SITE SUPPLEMENTAL INSTRUCTION

PROJECT: Forestside Estates
Attmar & Palleschi Drive
Brampton, ON

SITE SI NO. M-7

PURPOSE: To revise make-up air risers to suit space requirements & City Permits comments.

DRAWN	CHECKED	SCALE
MC	LM	1:50
DATE	PROJECT	DRAWING
MAY, 2019	18-017	M-41A
		OF

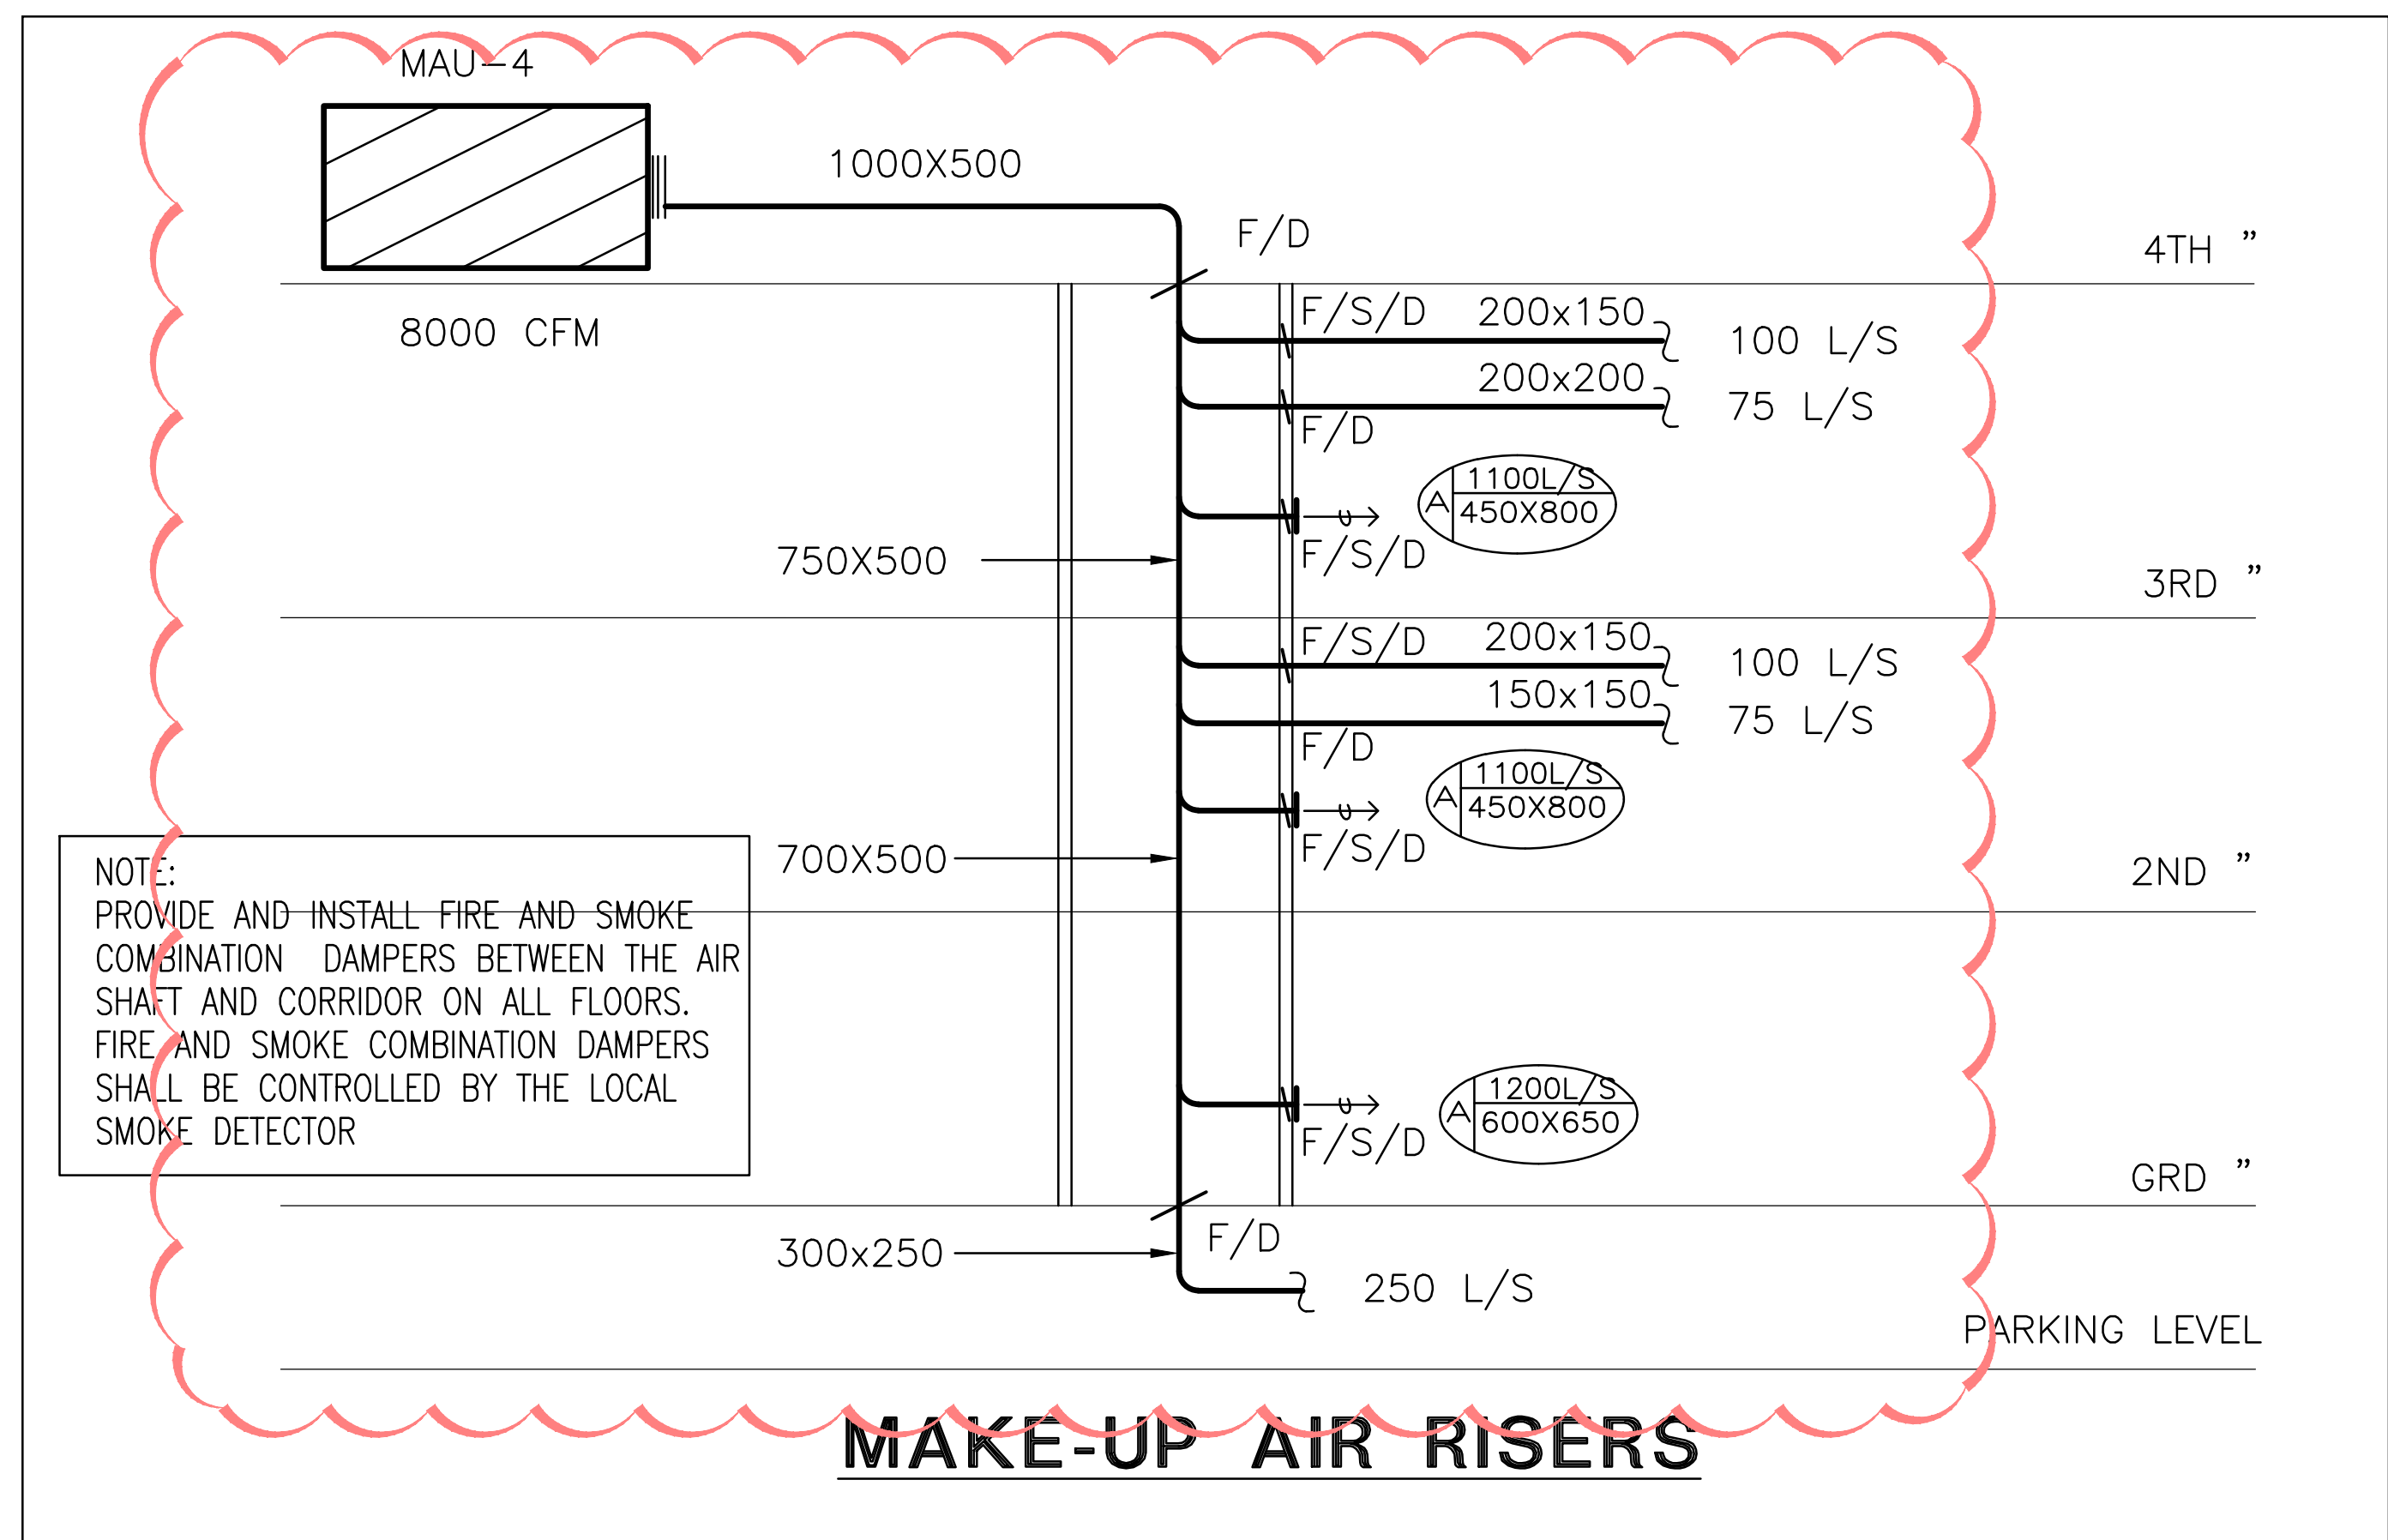
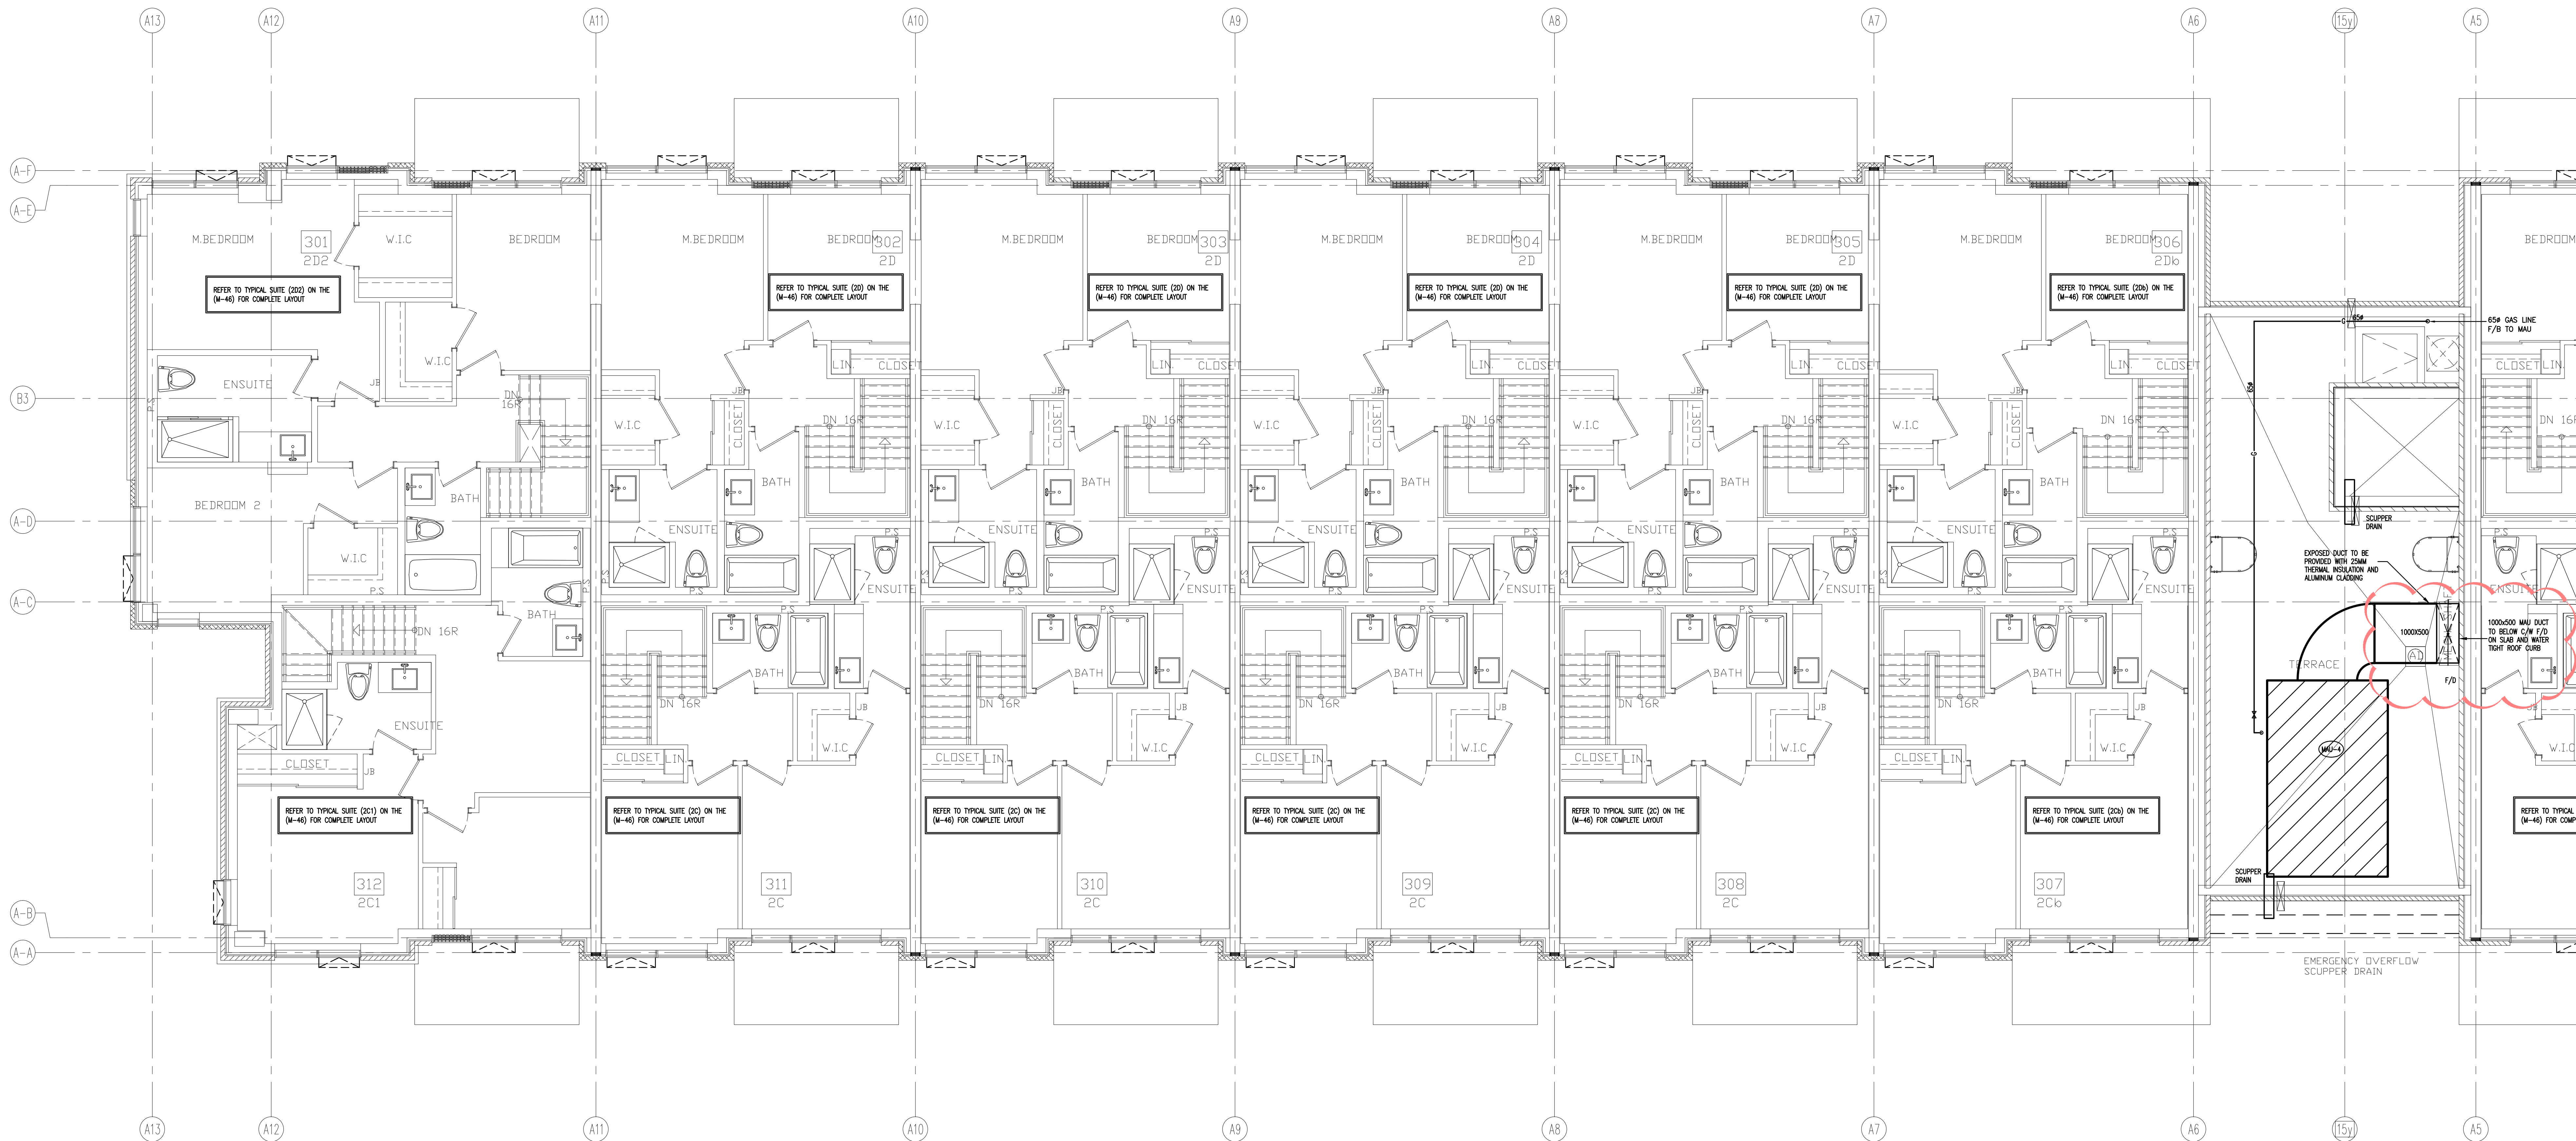
17.1 Clarify: Make-up air duct size.

17.2 Revise: Make-up air riser diagram.
